**Review of Vermont Yankee
Thermal Discharge Permit Requirements
and Analysis of
Connecticut River Water Temperature and Flow**

August 17, 2012

This report presents a review of National Pollutant Discharge Elimination System (NPDES) thermal discharge permit requirements for the Vermont Yankee Nuclear Power Station and an analysis of water temperature and river flow in the Connecticut River upstream, downstream, and adjacent to the Power Station. The NPDES permit specifies that the temperature rise associated with Vermont Yankee's thermal discharge be calculated using an equation. The equation, referred to as Equation 1.1, is described and its suitability for this application is evaluated and discussed.

Figure 1. Time series of water temperature, river flowrate and temperature rise near the Vermont Yankee Station on the Connecticut River, May – September 2006 (5 months).

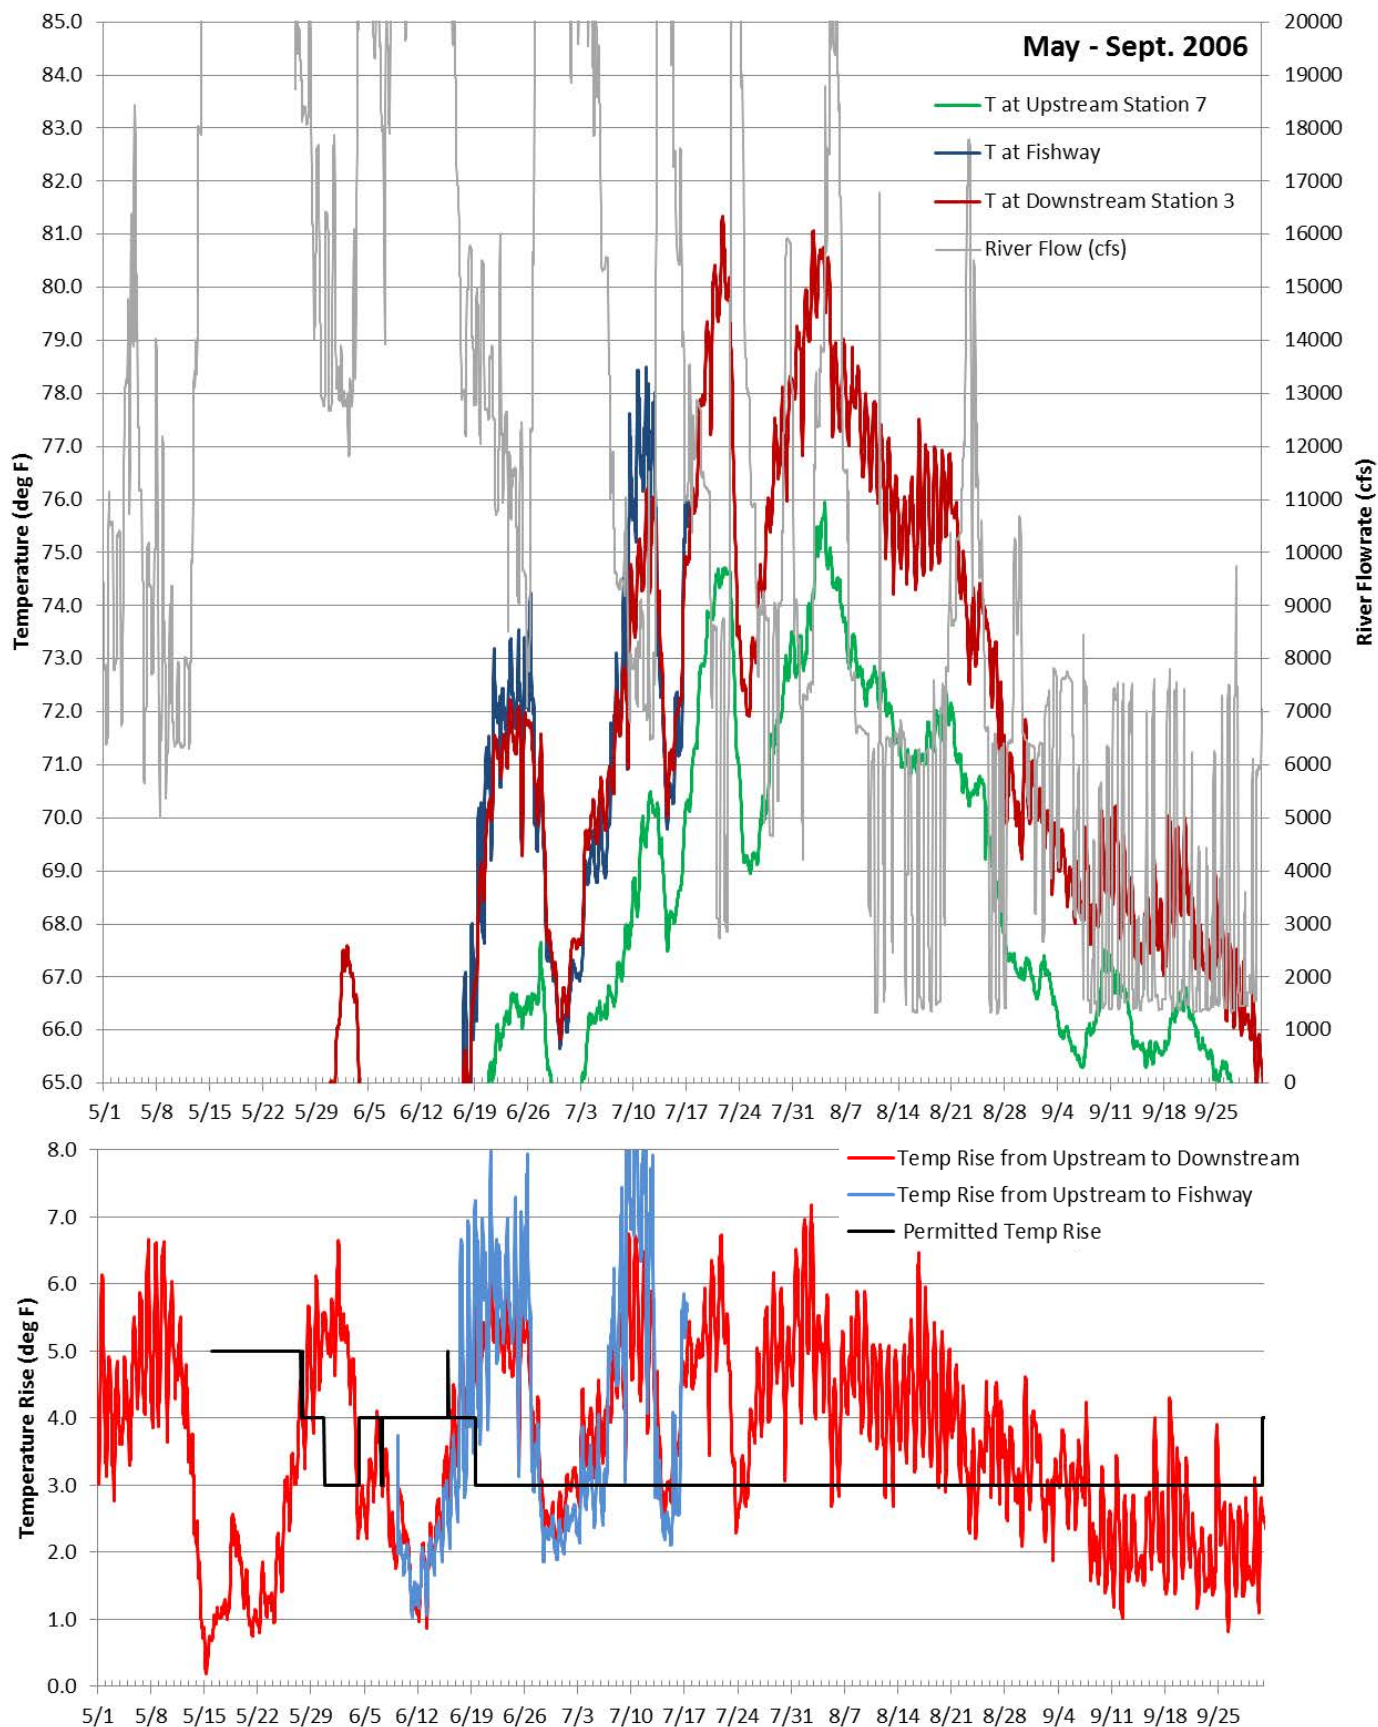
Figure 1 provides water temperature, river flow, and temperature rise over time during the period of May through September 2006. The upper plot shows water temperature at the upstream Station 7 (green), the Vernon Dam fishway (blue), and downstream Station 3 (red) on the left axis and river flowrate (gray) on the right axis. The lower plot shows NPDES-permitted temperature rise (black), temperature rise between Stations 7 and 3 (red), and between Station 7 and the fishway (blue). The format of Figure 1 is utilized in Figures 1 through 21.

Water temperatures ranged from less than 65°F in May to over 81°F during the summer of 2006. River flow varied dramatically from only 1,250 cfs to over 20,000 cfs. Temperatures at downstream Station 3 and in the fishway (when operational) were consistently higher than temperatures at Station 7. The lower plot shows that the NPDES-permitted temperature rise was frequently exceeded by actual temperature rises at Station 3 and the fishway and was often above the permitted value for extended periods. For each hourly set of measurements, the actual temperature rise was obtained by subtracting the upstream temperature from the downstream temperature, resulting in the temperature rise. Actual temperature rises, from upstream to downstream (in red in Figure 1), exceeded 6°F on numerous days and temperature rises at the fishway exceeded 8°F on several occasions.

Figure 2. Time series of water temperature, river flowrate and temperature rise near the Vermont Yankee Station on the Connecticut River, June 18 – July 15, 2006 (4 weeks).

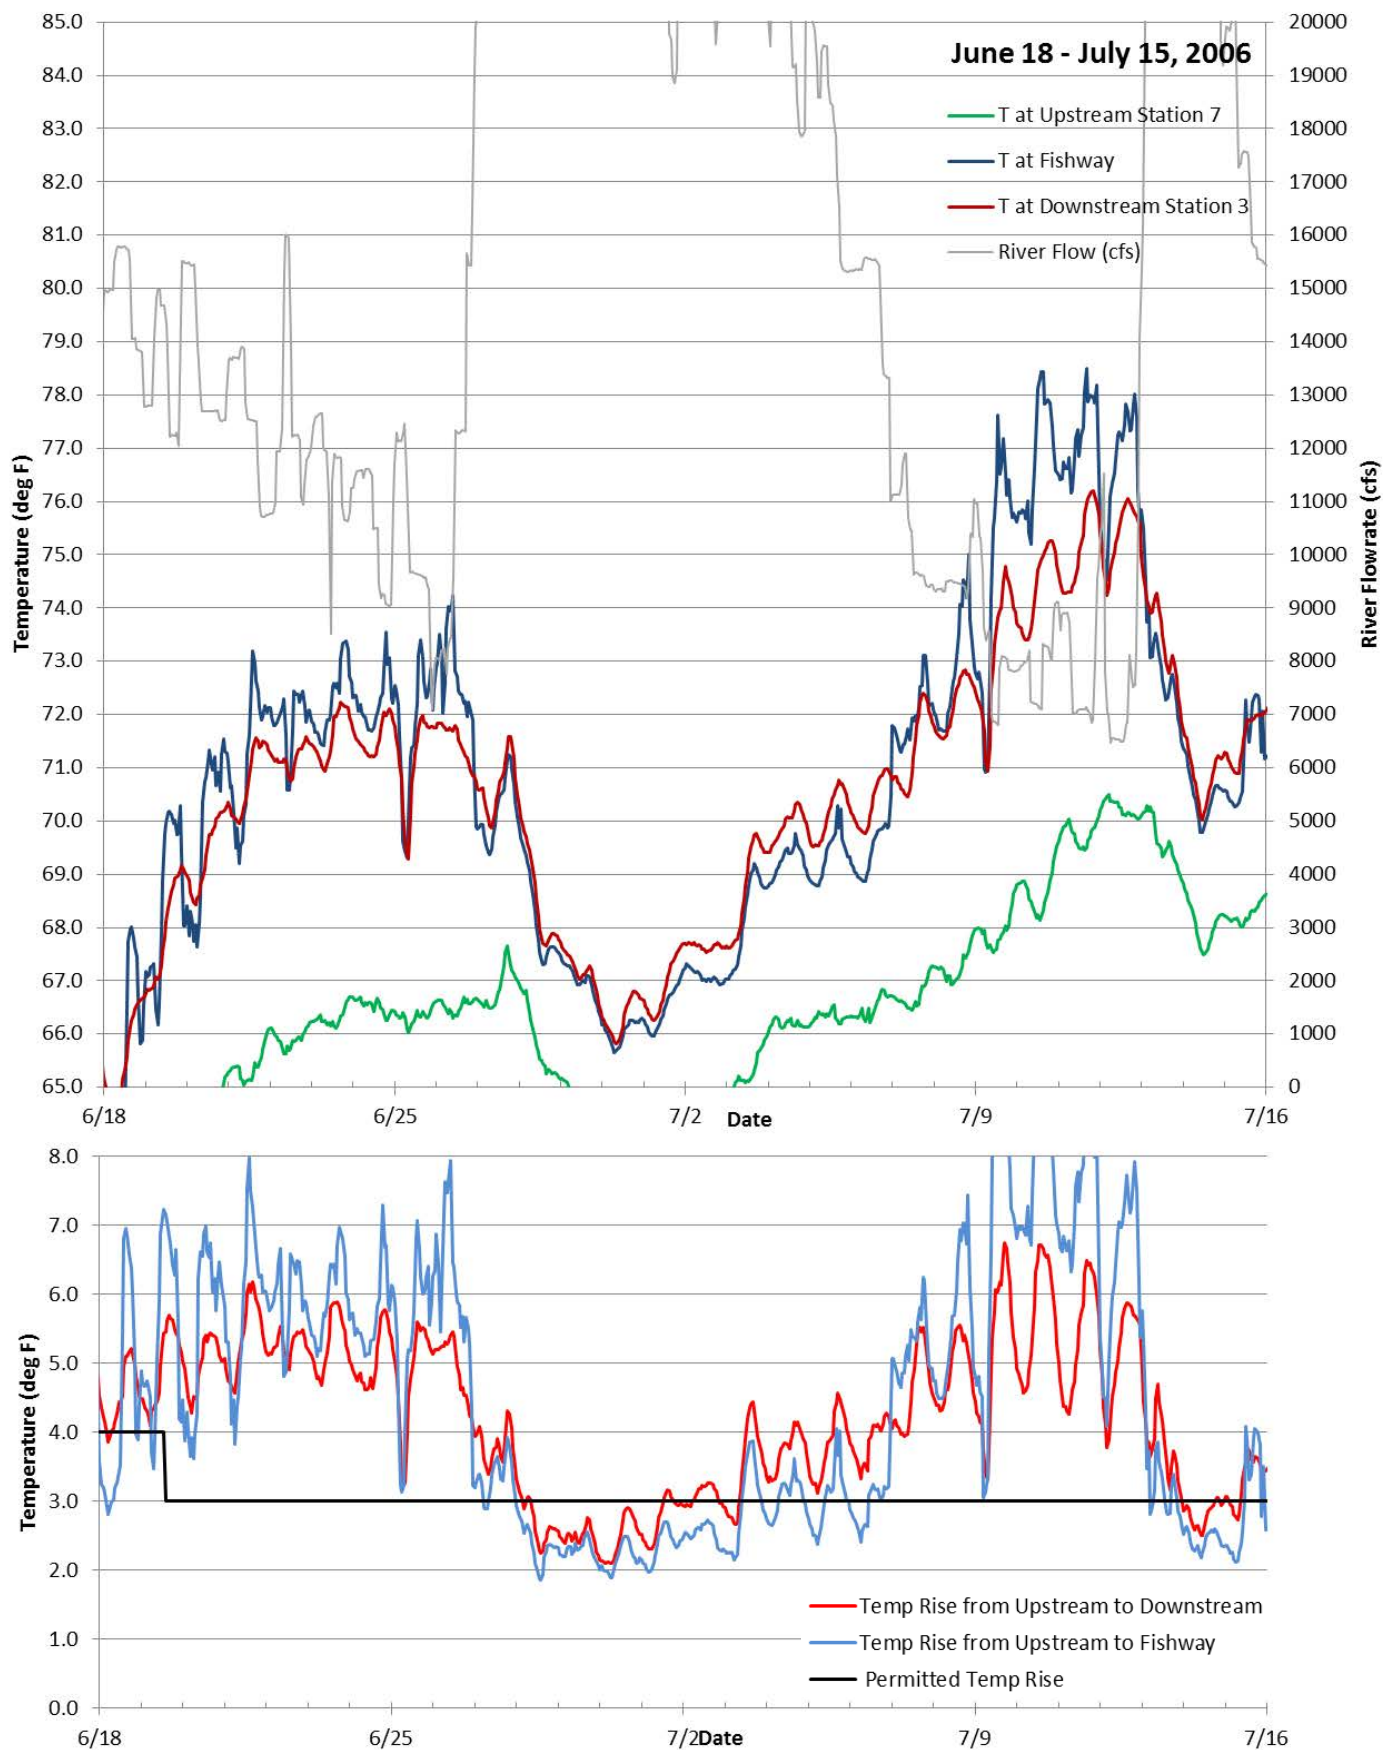
To get a closer look at the character of actual temperature rises, a four-week period during the fishway season was evaluated and is presented in Figure 2. River flowrates were high and variable during this period, ranging from 7,000 cfs to over 20,000 cfs. Actual temperature rise was often over 6°F and occasionally over 8°F, exceeding the permitted temperature rise of 3°F by 3 to 5°F. Temperature rises were observed to be lower during periods of very high river flow, such as the late June/early July period when flows exceeded 20,000 cfs. Figures 3 and 4 show flow and temperature in the river during one-week time periods during June and July 2006 and illustrate temperatures during important time periods relative to fish passage. For example, the actual temperature rise at the fishway exceeded 10°F on July 10, 2006, representing a 7°F exceedance of the permitted temperature rise (Figure 4).

Figure 22. Time series of water temperature and river flowrate near the Vermont Yankee Station on the Connecticut River, including USFWS data, May – September 2010 (5 months).

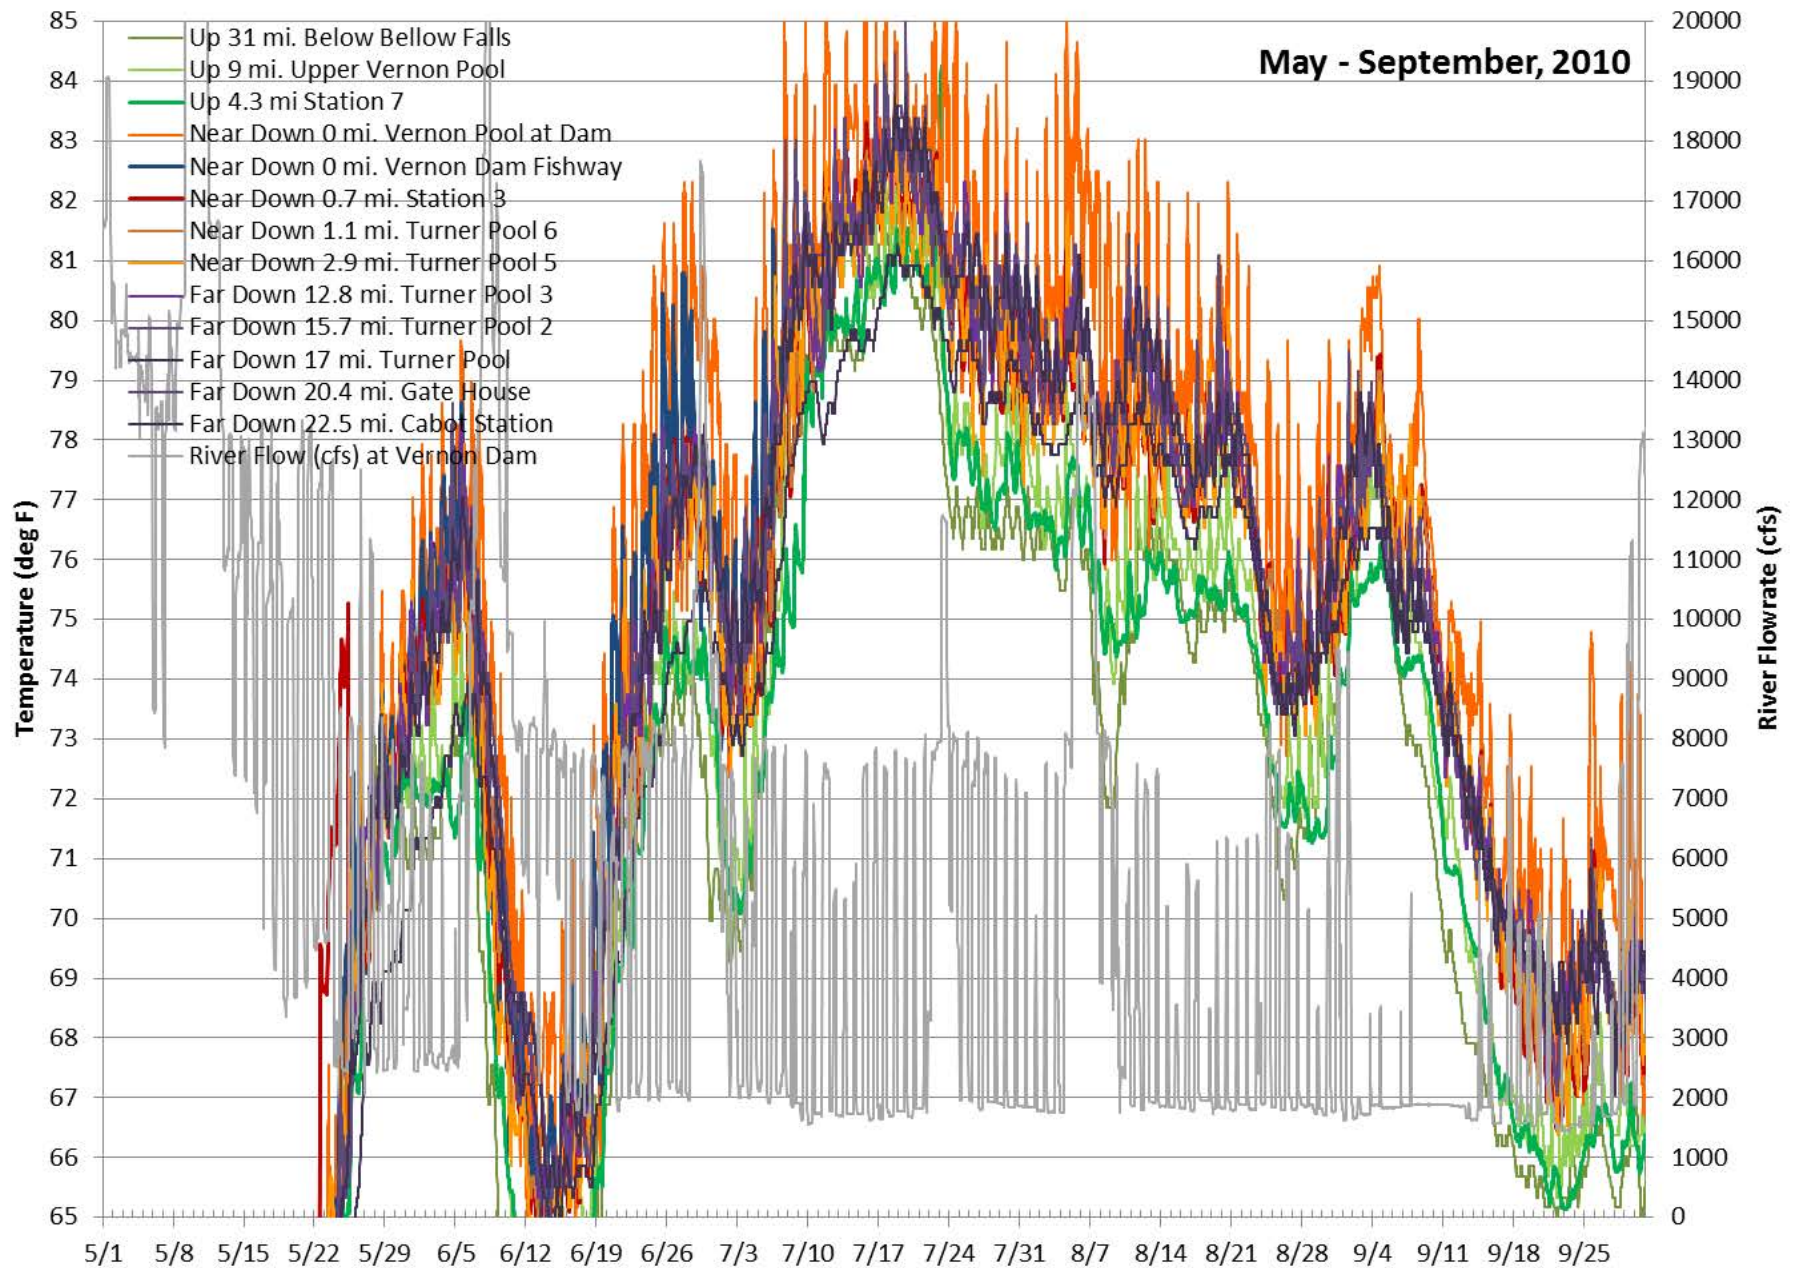
Figure 22 shows water temperature and river flow over time during the period of May through September 2010. This figure includes ten FWS temperature stations and three Vermont Yankee locations (Station 7, 3, and the fishway). Upstream stations are shown in shades of green, near-downstream stations are shown in red and orange, and far-downstream stations are shown in shades of purple. Near-downstream stations are situated from the Vernon Dam to 2.9 miles downstream and far-downstream stations are situated between 12.8 and 22.5 miles downstream of the dam. The Vermont Yankee stations retain the colors used in Figures 1 – 21 above: upstream Station 7 is green, fishway is blue, and downstream Station 3 is red.

Figure 22 is crowded and it is difficult to discern individual temperature records. Figure 22 illustrates the general trend that the upstream stations (green) tend to be cooler, the purple (far-downstream) and orange/red stations (near-downstream) appear to have similar temperatures with orange station spikes tending to represent the highest temperatures.

Figure 24. Time series of water temperature and river flowrate near the Vermont Yankee Station on the Connecticut River, including USFWS data, June 15 – July 12, 2010 (4 weeks).

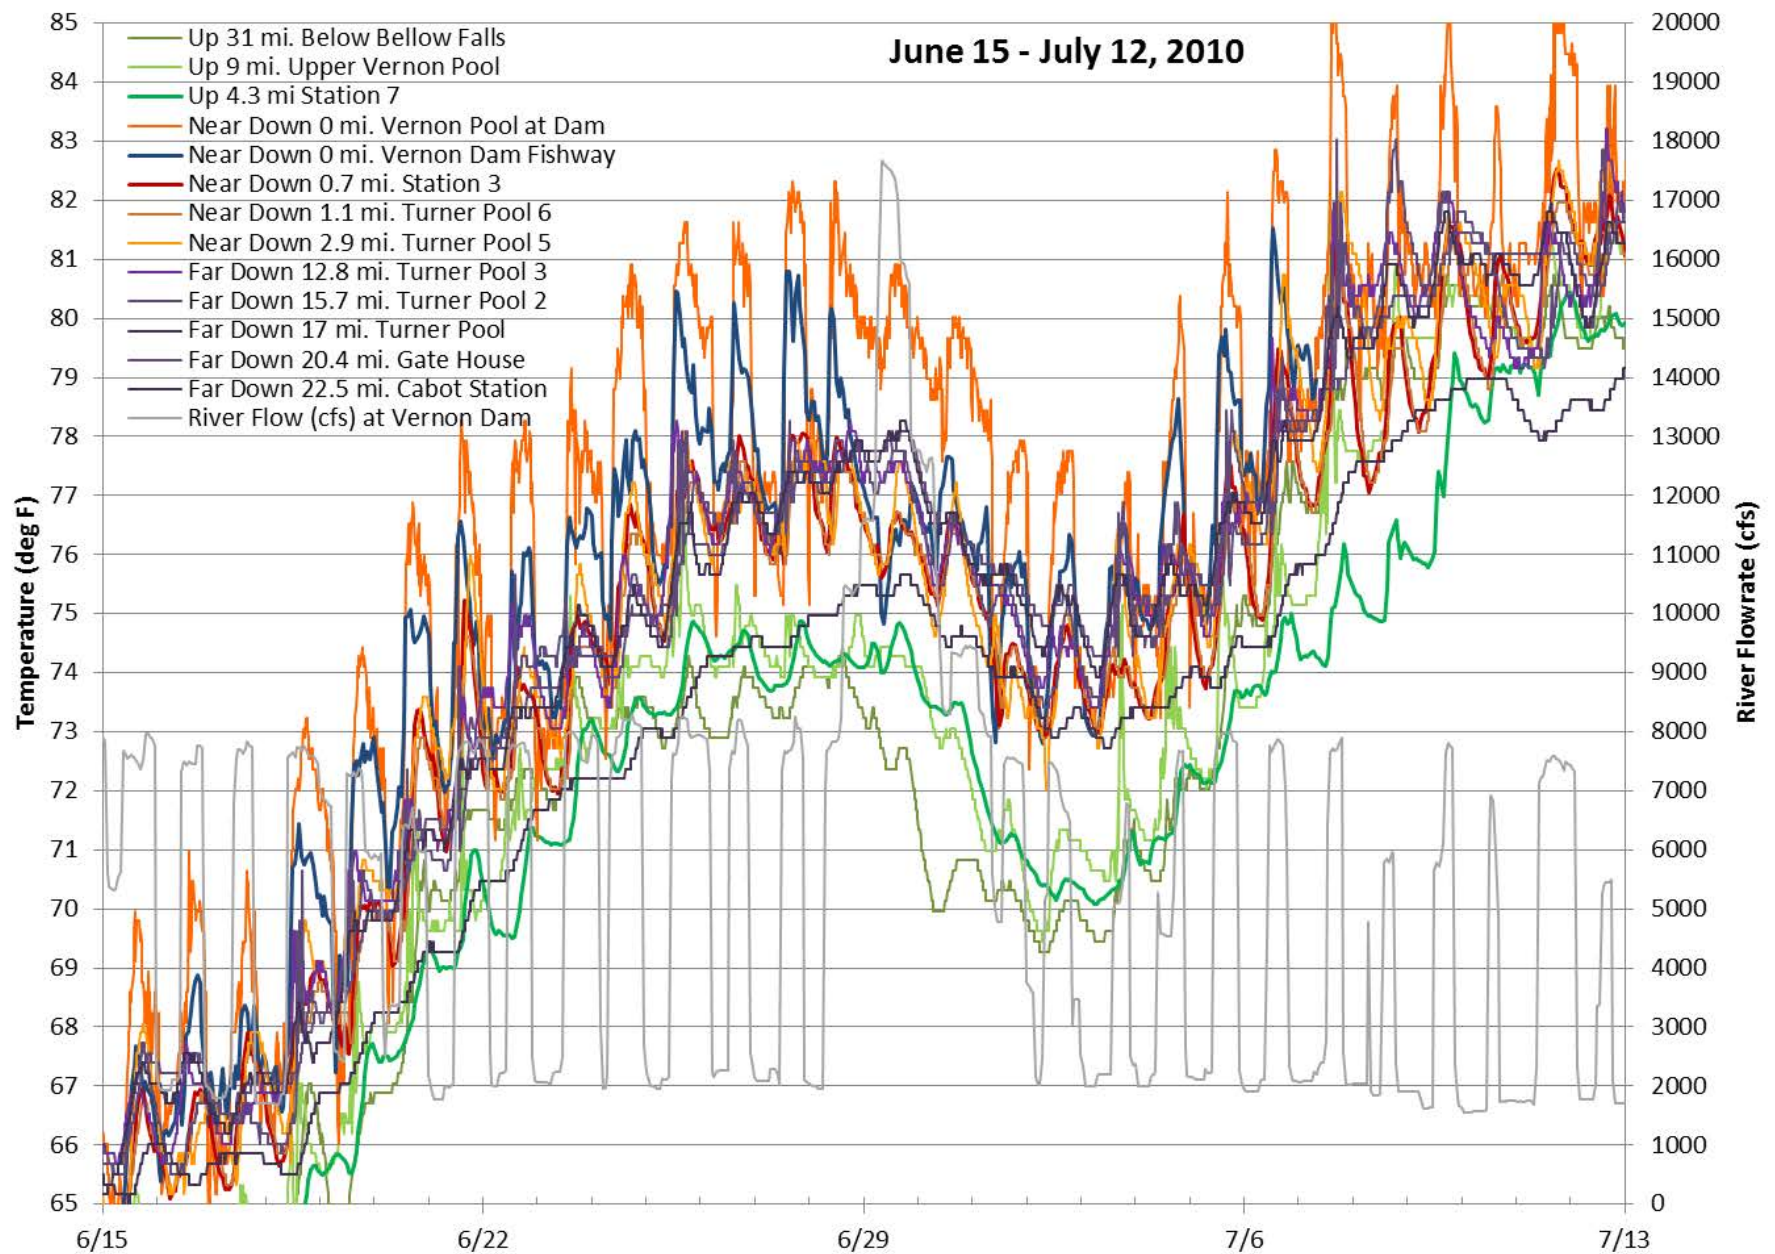
To evaluate the 2010 fishway season, two four-week periods were evaluated and are presented in Figures 23 and 24. During June 15 to July 13 (Figure 24), river flow rates typically varied through a large range (e.g., ~2,000 to ~8000 cfs) at least once per day. The highest water temperatures (orange) were at the Vernon Pool at Dam station (#43) immediately above the dam on the New Hampshire side of the river. The peak fishway temperatures (blue) coincide with the peak Vernon Pool Dam station temperatures. The near-downstream (orange/red) and far-downstream (purple) temperatures tend to be warmer than the upstream temperatures (green).
